LIBERTY HIGH SCHOOL Administration and Student Commons Modernization

Addendum 02

DECEMBER 21, 2020

Architect's Project No.: 1783.00

SHEET NUMBER ADDENDUM 02 A-B5.1

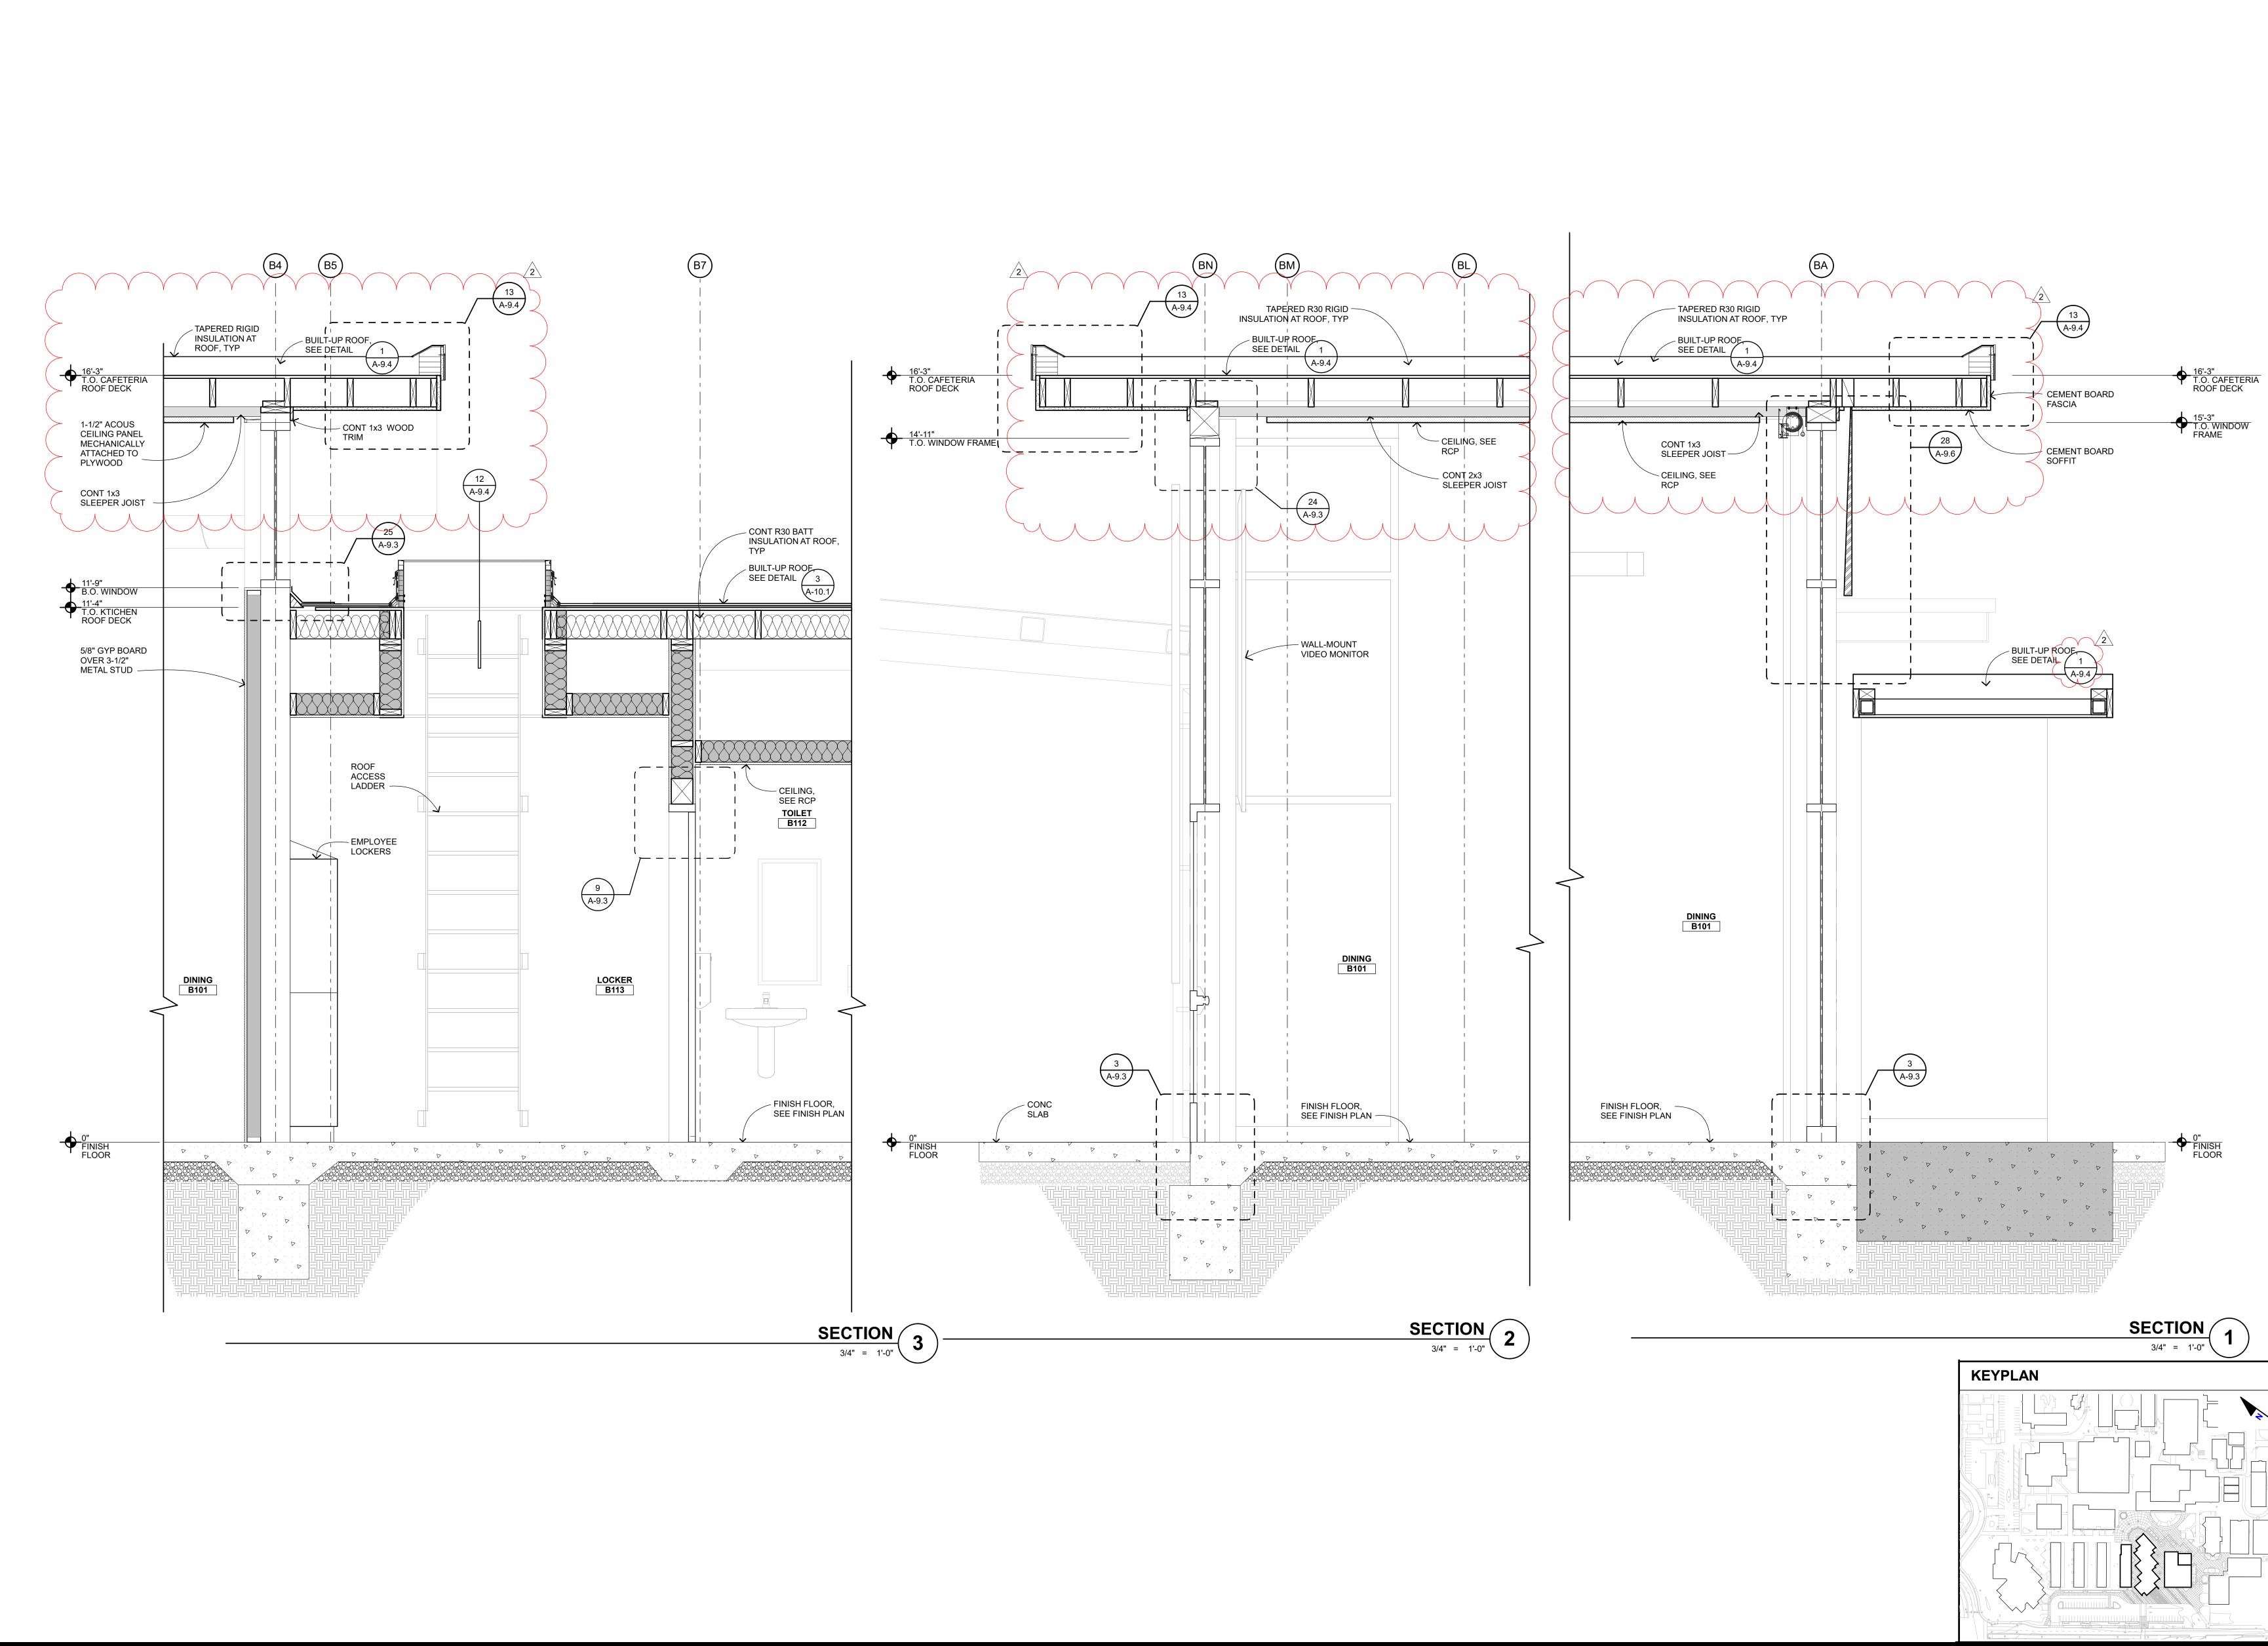
The following drawings dated December 18, 2020 denoted **Addendum 02** supersede and replace previous drawings with the same titles:
